REMARKS

Amendments to the Drawings

FIG. 4

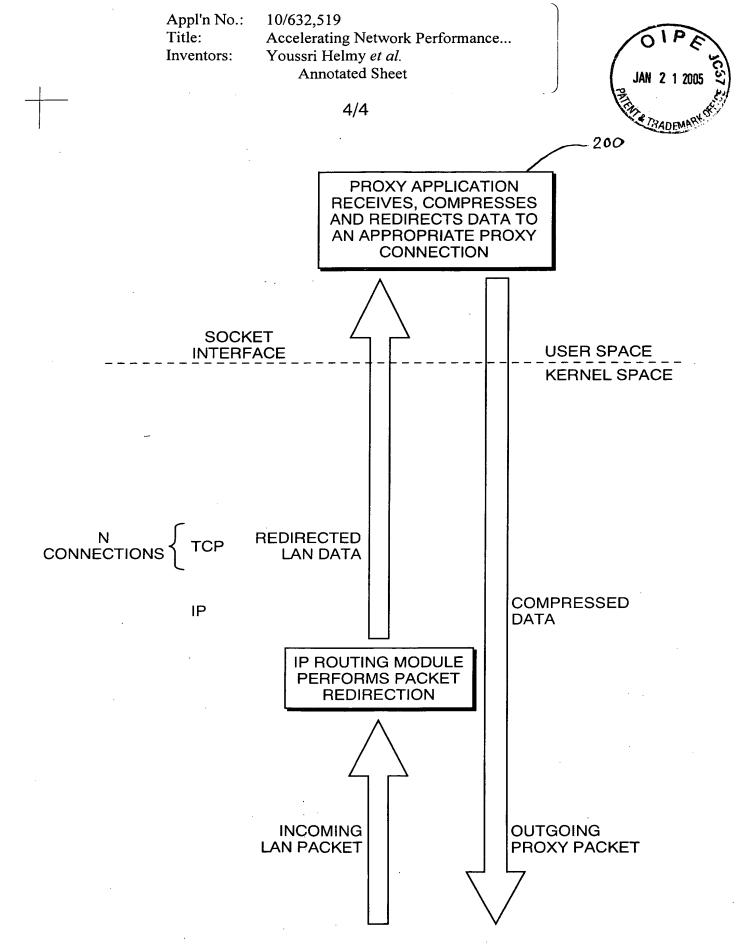
- 1. The disclosure was objected to because of informalities, in particular with reference to the phrase at page 10, lines 21-22. This phrase has now been corrected. The Applicants have reviewed the remainder of the specification and have corrected other typographical errors.
- 2. Fig. 4 was objected to as lacking a reference numeral "200". This reference numeral has now been added to the "proxy application" block which appears at the top of the replacement sheet enclosed herewith.
 - 3. Claims 1 through 3 were objected to because of various informalities.

Reference number 200 is being added to Fig. 4. Please refer to the attached marked up copy of the drawing.
